ECE/TRANS/WP.29/2010/29  
18 December 2009

Proposal for the 01 series of amendments to Regulation No. 98  
(Motor vehicles headlamps equipped with gas-discharge light sources)

Submitted by the Working Party on Lighting and Light-Signalling \*/

Figure A: Spherical coordinate measuring system

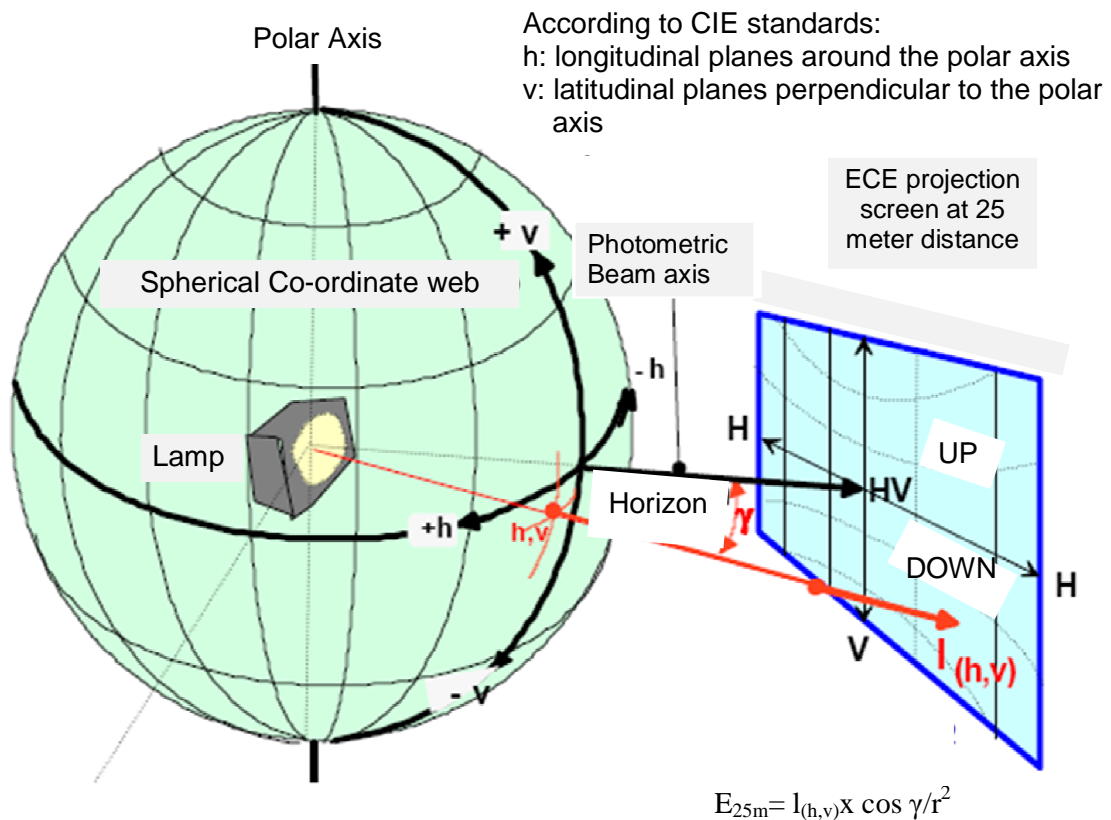
Annex 3, amend to read:

"Annex 3

SPHERICAL COORDINATE MEASURING SYSTEM  
AND TEST POINT LOCATIONS

Figure B: Passing beam for right-hand traffic

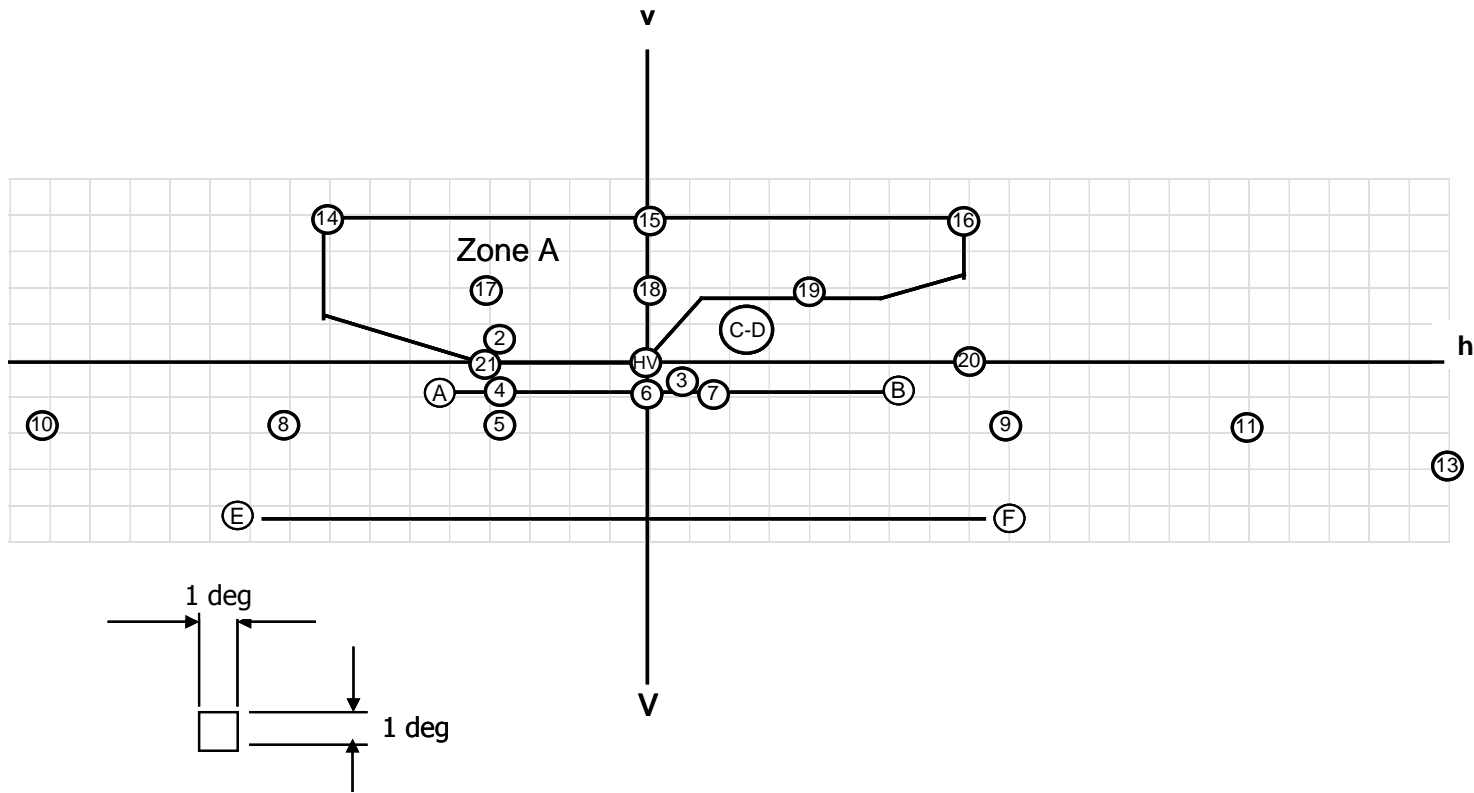
"6.2.5. After more than 10 minutes after ignition the luminous intensities at the test points referred to in the table below and in Annex 3 figure B (or mirrored about the VV line for left-hand traffic) shall meet the following requirements:

h-h = horizontal plane , v-v = vertical plane passing through the optical axis of the headlamp

The test point locations for left-hand traffic are mirrored about the VV line

Figure C: Driving beam test points

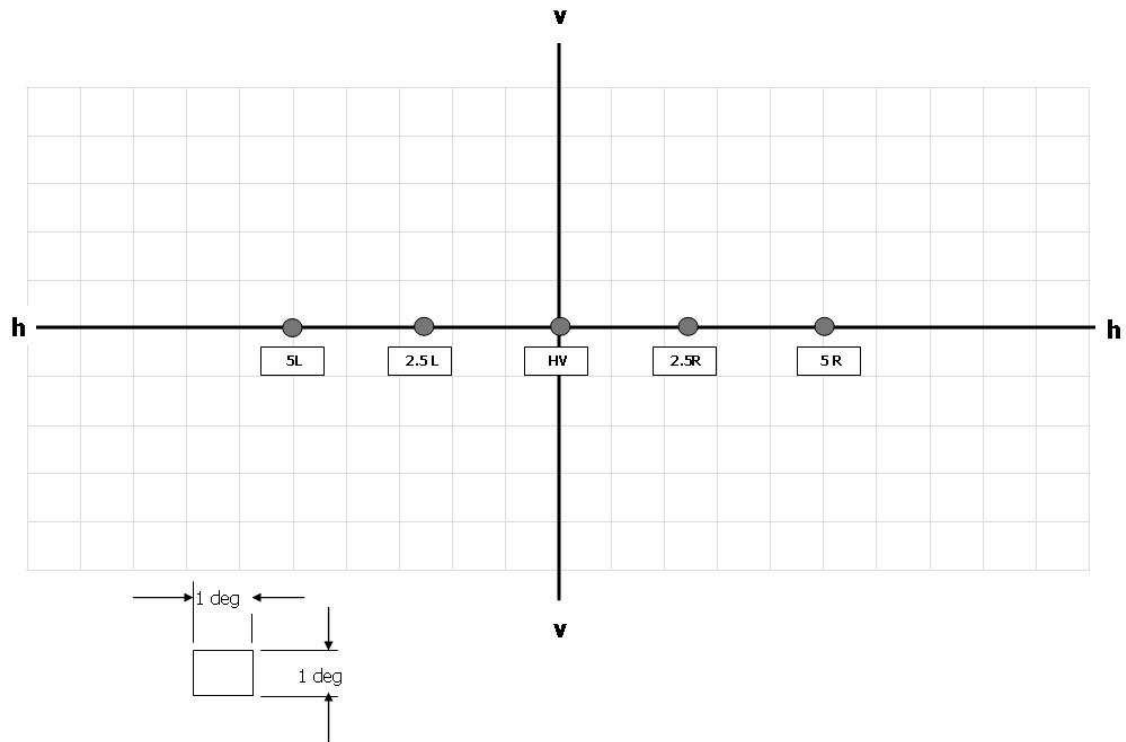
"6.3.3. Referring to Annex 3 Figure C, and the table below, the luminous intensity distribution of the driving beam shall meet the following requirements.

h-h = horizontal plane , v-v = vertical plane passing through the optical axis of the headlamp
